No. 2243  
ATA Code 32-10

**SUBJECT:** LANDING GEAR - INSTALLATION OF MAIN LANDING GEAR SINGLE PIECE BRACE NUT AND COLLAR AND ELLIPTICAL BUSHING RETAINER

**EFFECTIVITY:** BEECHCRAFT Skipper 77, serials WA-1 through WA-312.

**Service Bulletin No. 2243**

Figure 1

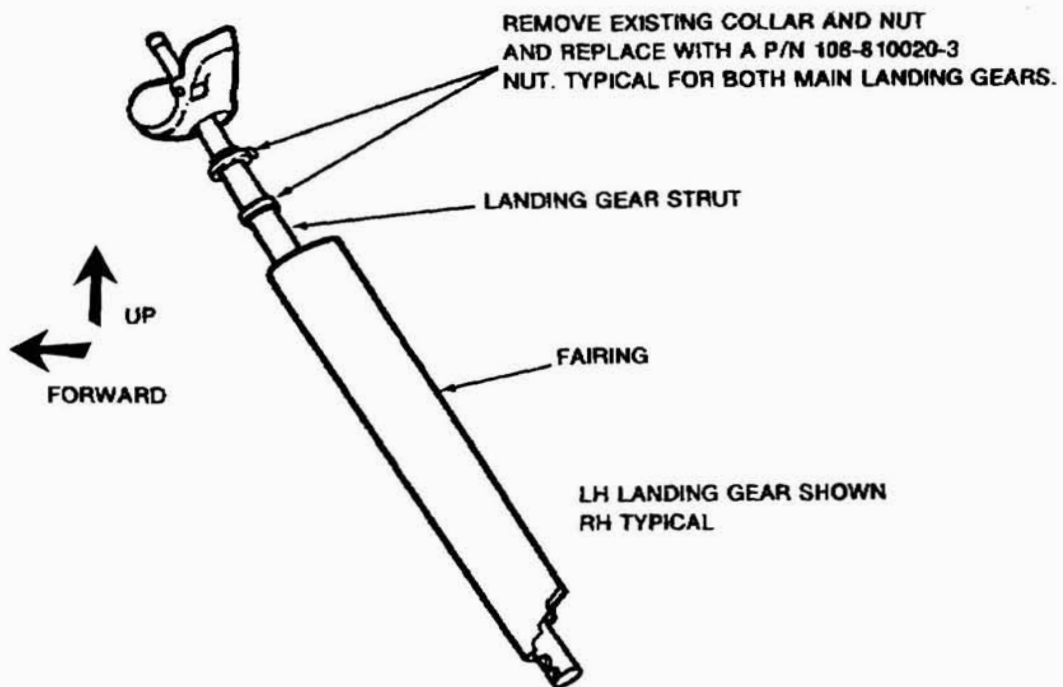
1. Refer to Chapter 7 of the Maintenance Manual and place the airplane on jacks.
2. Refer to Chapter 32-10 of the Maintenance Manual for removal of the main landing gear. Remove only one gear at a time.
3. Refer to Figure 1 and remove and discard the existing collar and nut from the LH, RH or both landing gear struts. Remove the adhesive from the strut.

4. Install a new P/N 108-810020-3 retainer nut. Do not tighten until Step 5 has been accomplished. The single piece brace nut and collar (retainer nut) does not require bonding.
5. Prior to reinstallation of the landing gear struts, check to see if BEECHCRAFT Service Bulletin No. 2003 has been accomplished previously. Service Bulletin No. 2003 modifies the elliptical bushing (Fig 2) by the addition of the bushing retainer contained in Kit No. 77-8003-1 S. If this modification has not been accomplished, remove the elliptical bushings from the fuselage fittings and perform the following:
  - a. Locate the two tooling holes in the inboard side of the elliptical bushing. Drill a .2720 inch diameter hole to a depth of .56 inch. Tap the holes to 5/16 - 24 thread, starting with a tapered tap and finishing with a bottoming tap as shown in Figure 2.

Figure 2

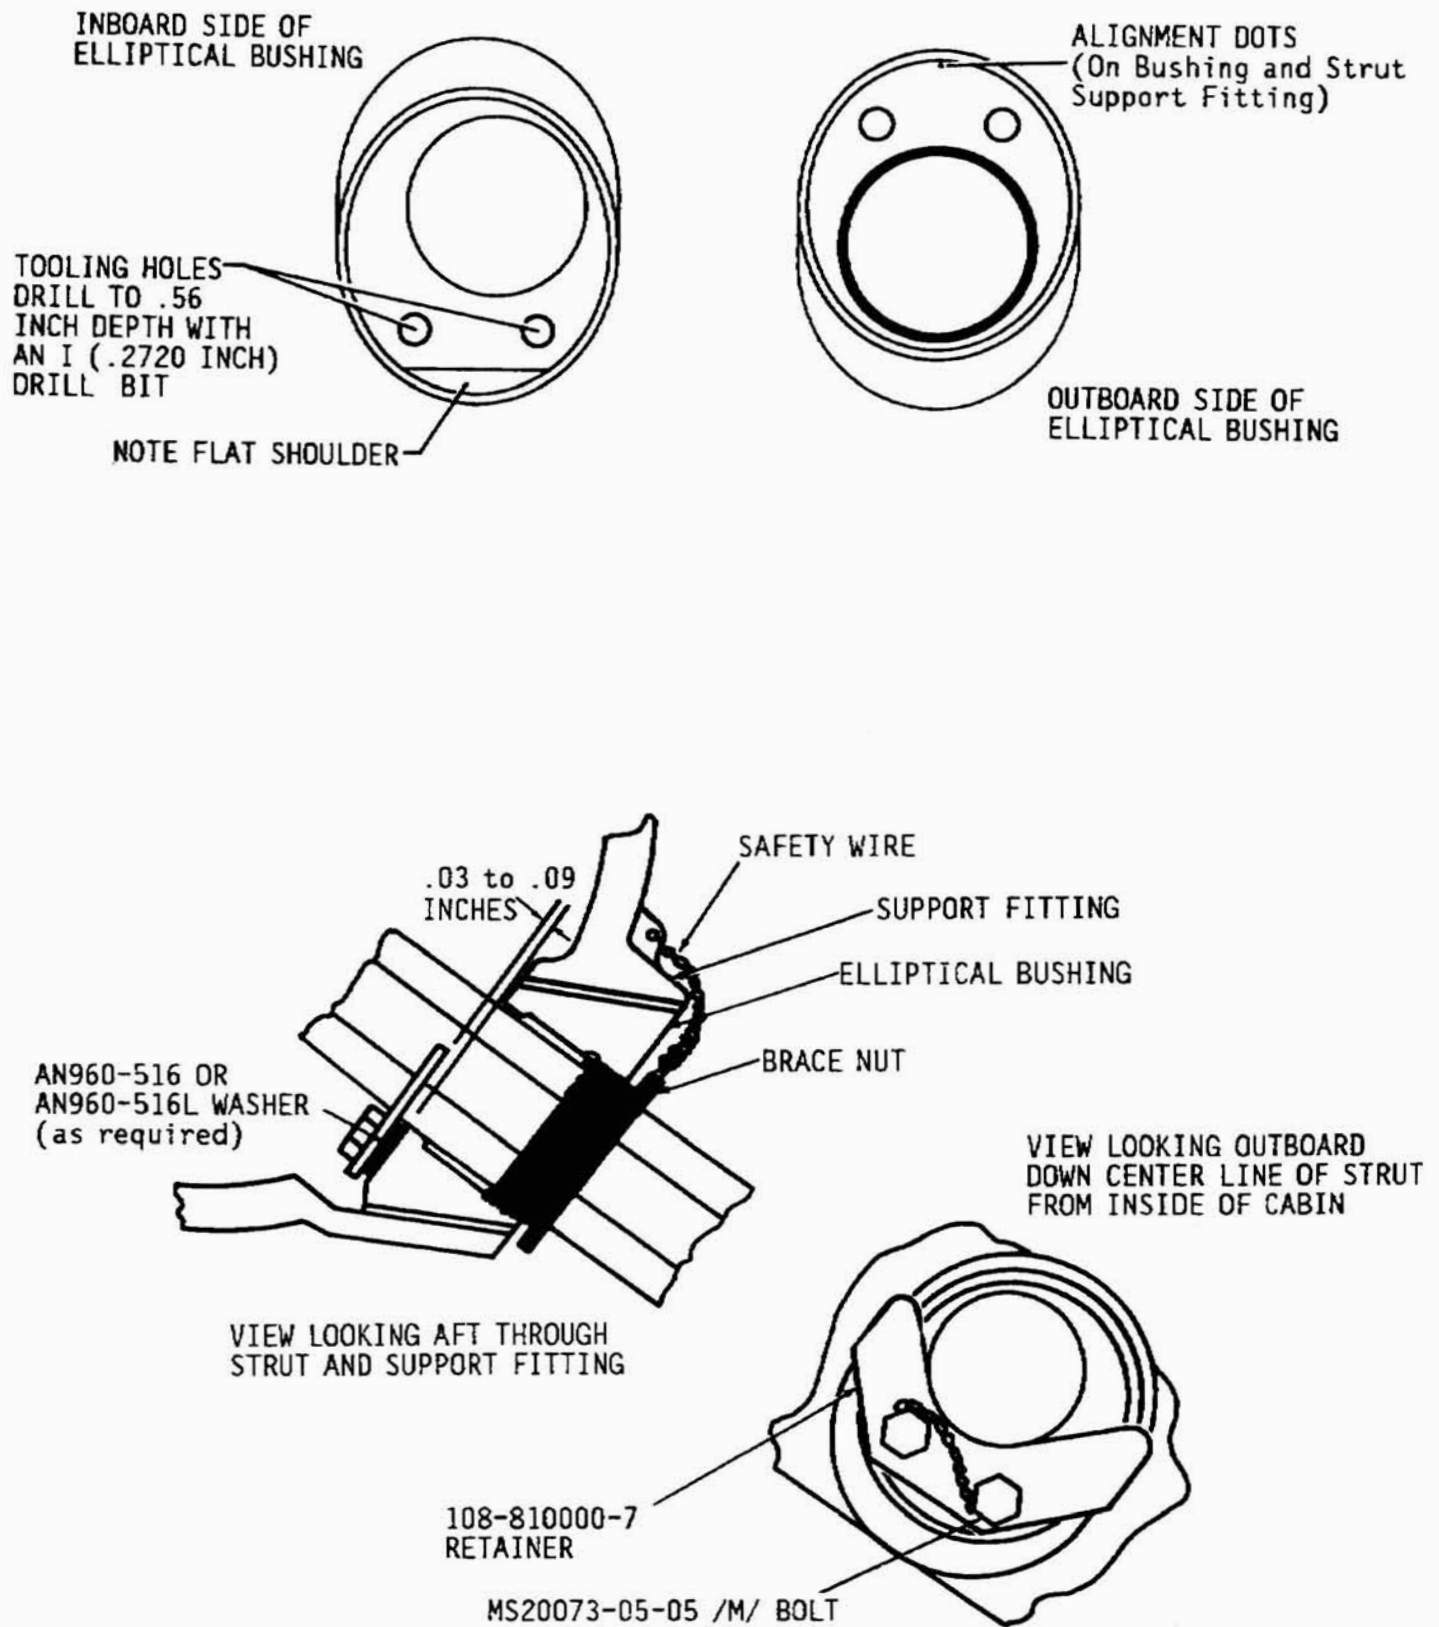
- b. When installing the retainer ensure that the alignment dots on the elliptical bushing and strut support fitting are aligned exactly. Using a spanner wrench, torque the P/N 108-810020-3 retainer nut (Fig.2) to 125-150 inch-pounds. Ensure that the alignment dots align after torquing. Safety the retainer nut.

- c. Install a P/N 108-810000-7 retainer as shown in Figure 2 using two P/N MS20073-05-05 /M/ bolts. Place P/N AN960-516 or P/N AN960-516L washers (obtain locally) between the bushing and retainer as required to maintain a spacing of .03 to .09 inch between the retainer and support fitting as shown in Figure 2. Torque the bolts to 56 - 78 inch-pounds and safety.

- d. Reinspect for .03 to .09 inch clearance between the retainer and support fitting.
